**Objection to: 2017/3835/P and 2017/4297/L**

I represent the nine leaseholders of The Clocktower at 49 Heath Street, London NW3 6UD. I am writing to express our objection to the planning permission and listed building consent applications 2017/3835/P and 2017/4297/L.

fig.1

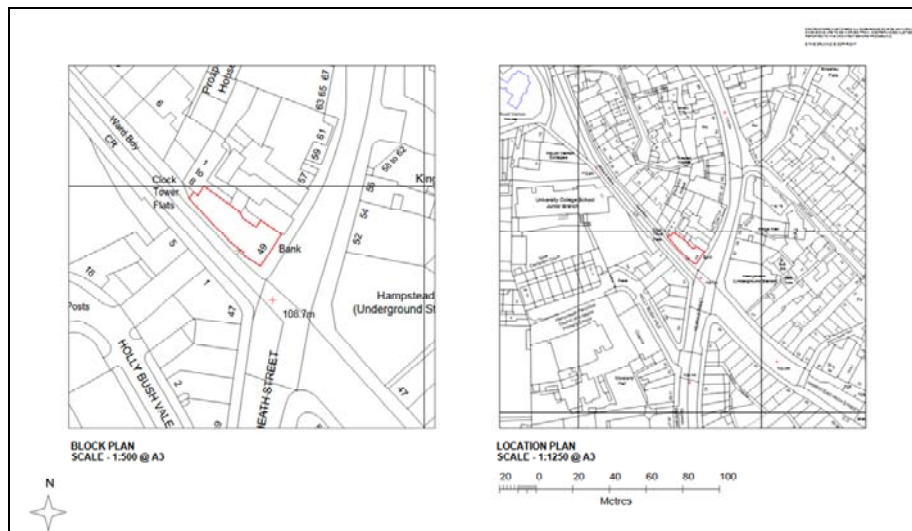
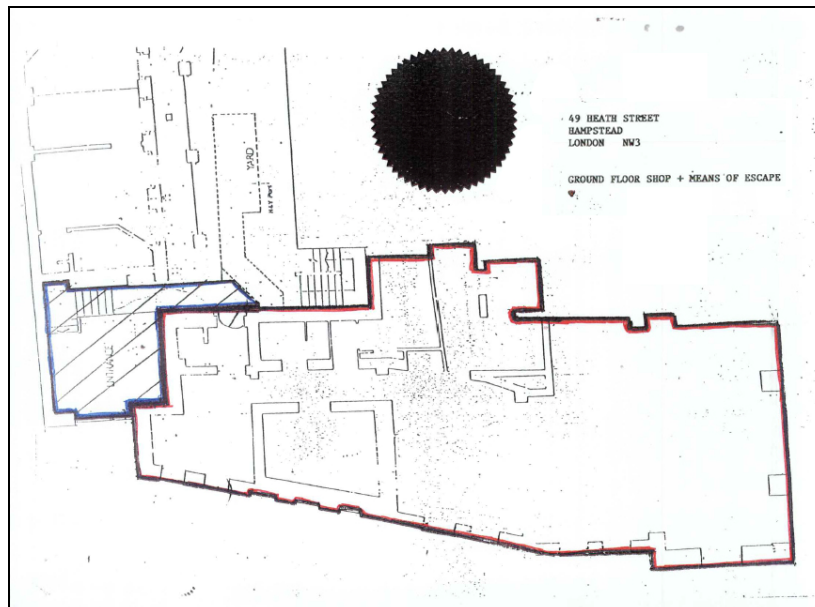
The file titled 'OS Map' that has been submitted doesn't appear to meet Camden Council's planning criteria which state that *"a red line should be used to highlight the boundary of the development site."* The 'BLOCK PLAN' and 'LOCATION PLAN' show an area outlined in red [fig.1]. However, the development site is situated outside of this. The proposed location of the air conditioning units is in a courtyard situated behind the commercial premises and overlooked exclusively by nine residential apartments. This area falls outside of the land included in the lease for the commercial premises, which is outlined in red [fig.2].

fig. 2

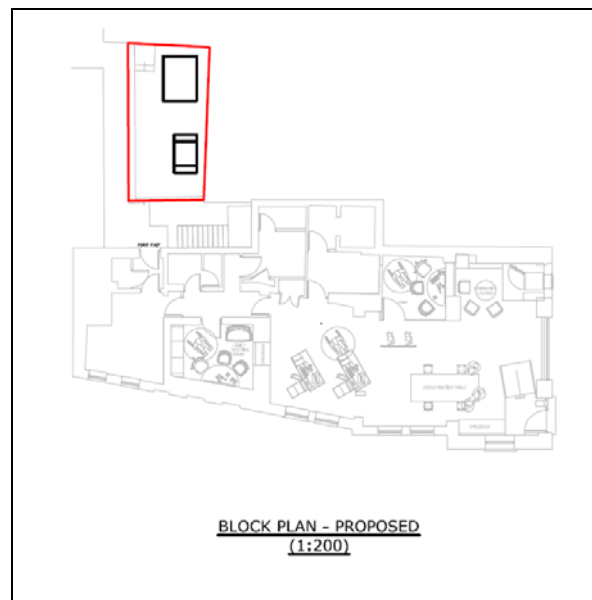
The residential courtyard where the air conditioning units have been installed does not form part of the premises leased by Nationwide [fig.2]. The right to retain the air conditioning units in this location is subject to Nationwide making good any damage caused to this area of the building as a result of these units.

fig.9

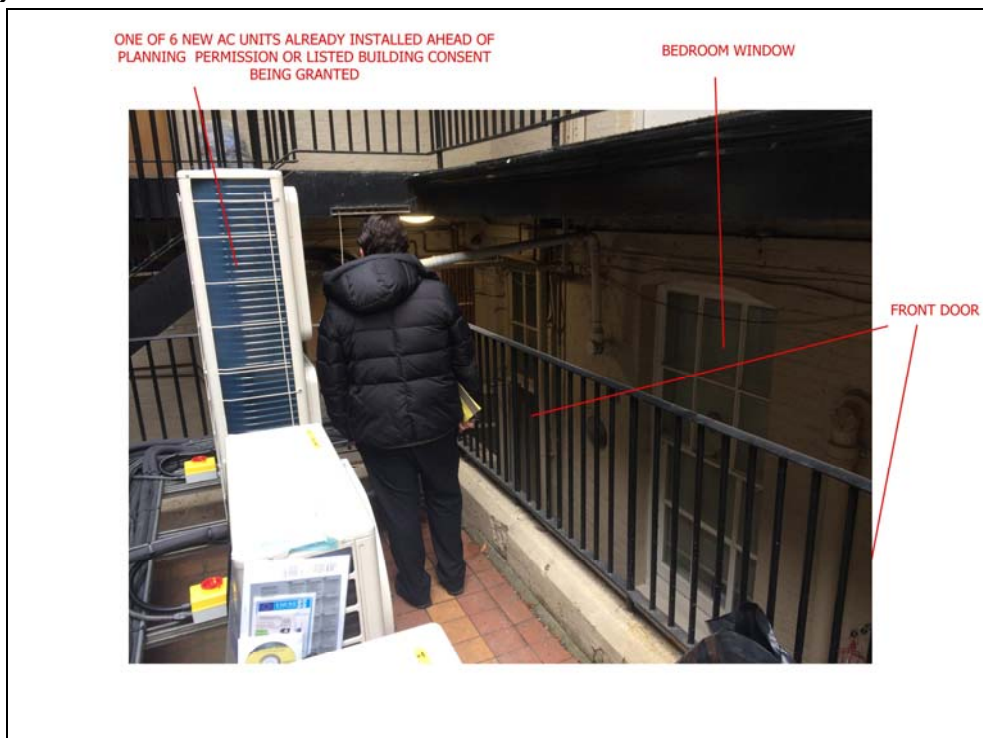
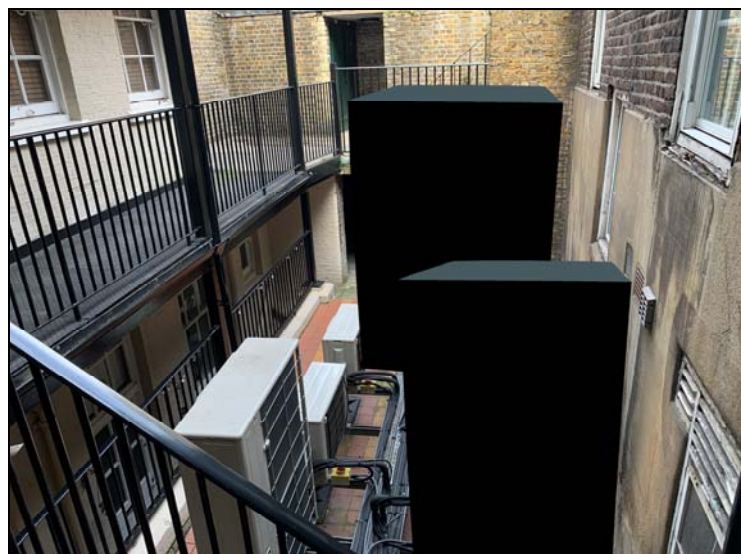
The air conditioning units that were installed in August 2017 [fig.9] are much taller than what was there previously and now block daylight into the ground floor apartment.

fig.11

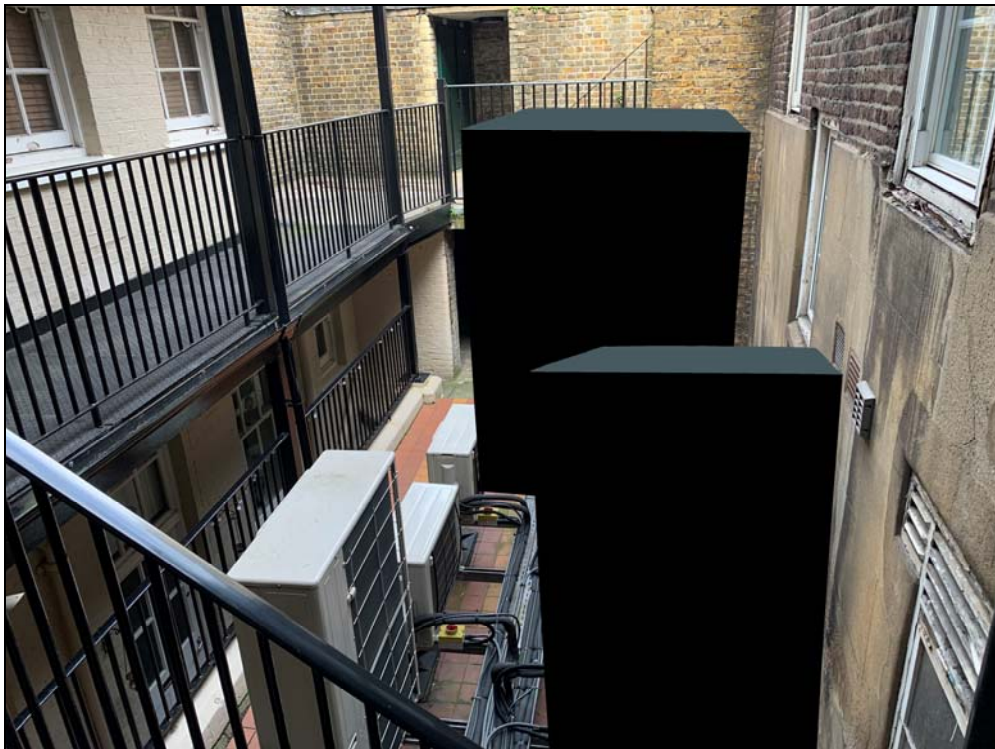
Under the heading "Scale" it is a little misleading to simply suggest that " The proposals reduce the amount of units currently within the courtyard." when the reality is they are far larger than what is currently there and will therefore completely dominate the entire area [fig.11] with a much greater footprint and much taller units.
